Subject: **Revised Permit Modification Request for the Section 404 Individual Permit, Section 401 Individual Water Quality Certification and CAMA Major Development Permit** for the proposed improvements to US 70 from existing four lanes at Radio Island to north of Olga Road (SR 1426), Carteret County, State Project No. 8.1162501, Federal Aid Project STPNHF-70(43), TIP R-3307, Debit \$570 (NCDWR) and \$100 (NCDCM) from WBS 34528.1.1

Permit Drawing
Sheet 5a of 34
Revised 23 May 2016

**Permit Drawing
 Sheet 34 of 34
 Revised 23 May 2016**

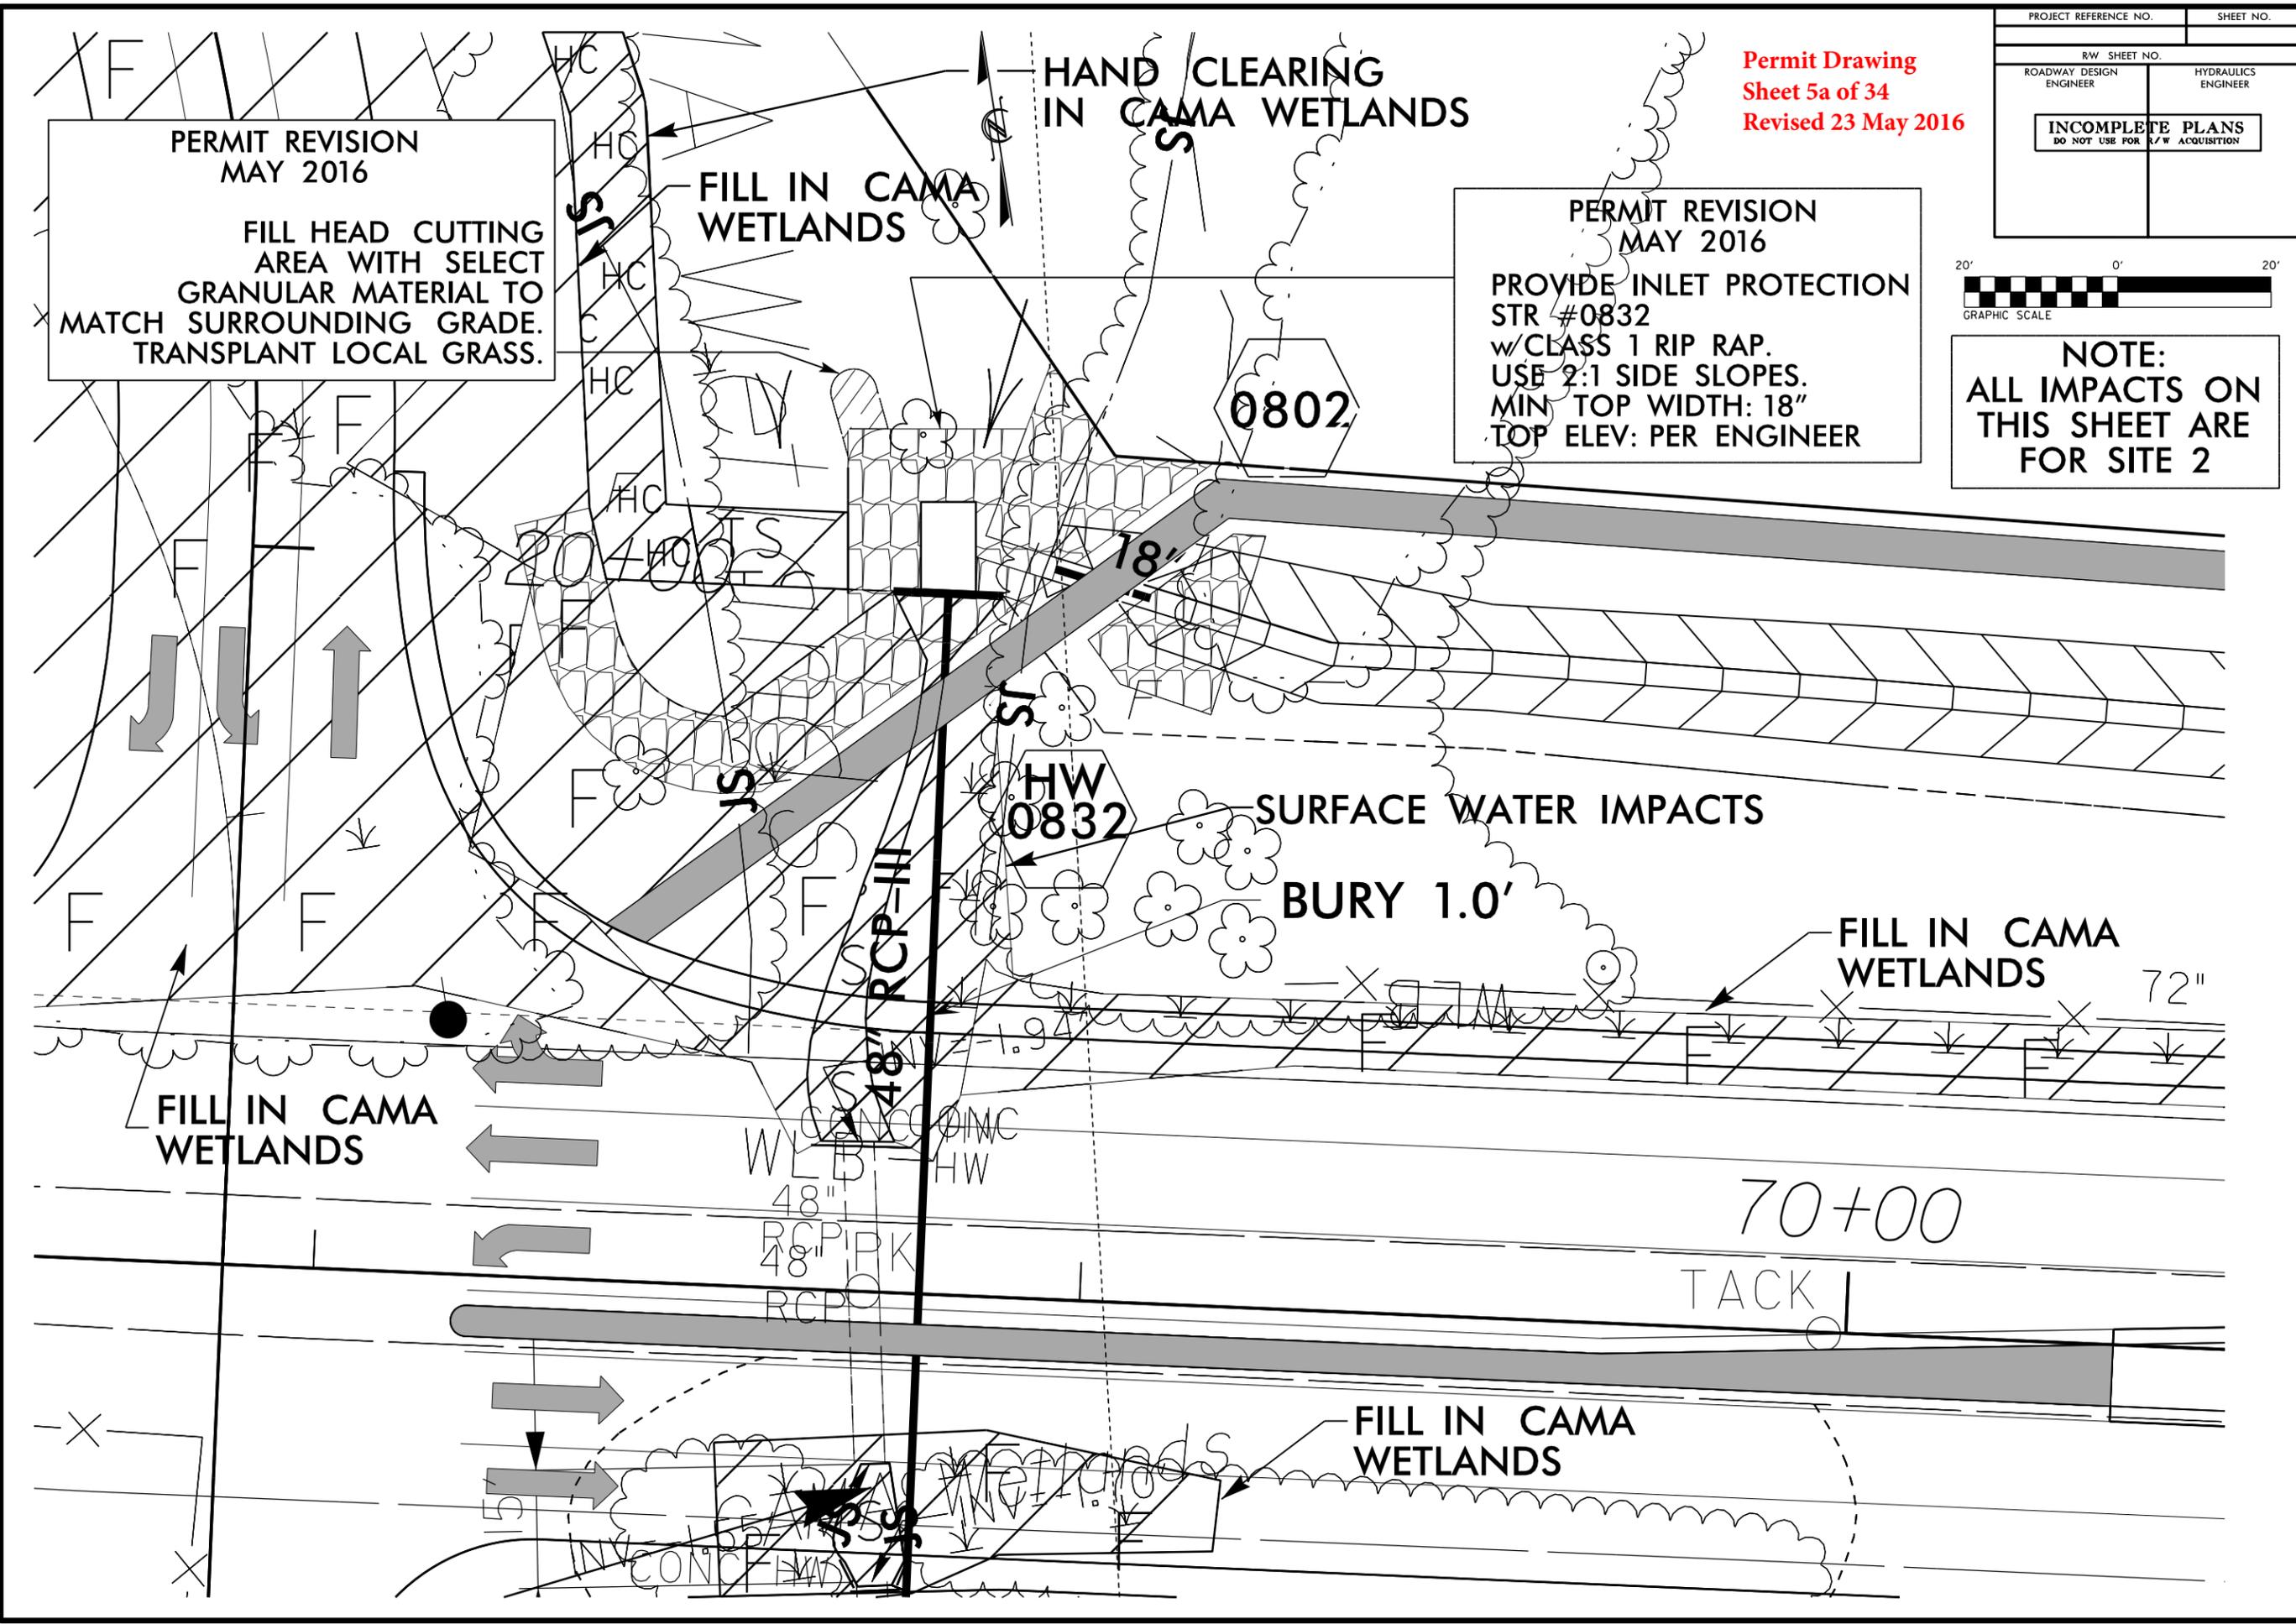
As noted during a recent field review, additional rip rap will be required for the 48" RCP at Site 2 for inlet protection, resulting in an additional 0.01 acre of fill in surface waters. Additionally, a small head cut will be filled with select granular material, matching surrounding grade and transplanted with local grasses.

PERMIT REVISION
MAY 2016

FILL HEAD CUTTING AREA WITH SELECT GRANULAR MATERIAL TO MATCH SURROUNDING GRADE. TRANSPLANT LOCAL GRASS.

PERMIT REVISION
MAY 2016

PROVIDE INLET PROTECTION STR #0832 w/CLASS 1 RIP RAP. USE 2:1 SIDE SLOPES. MIN TOP WIDTH: 18" TOP ELEV: PER ENGINEER
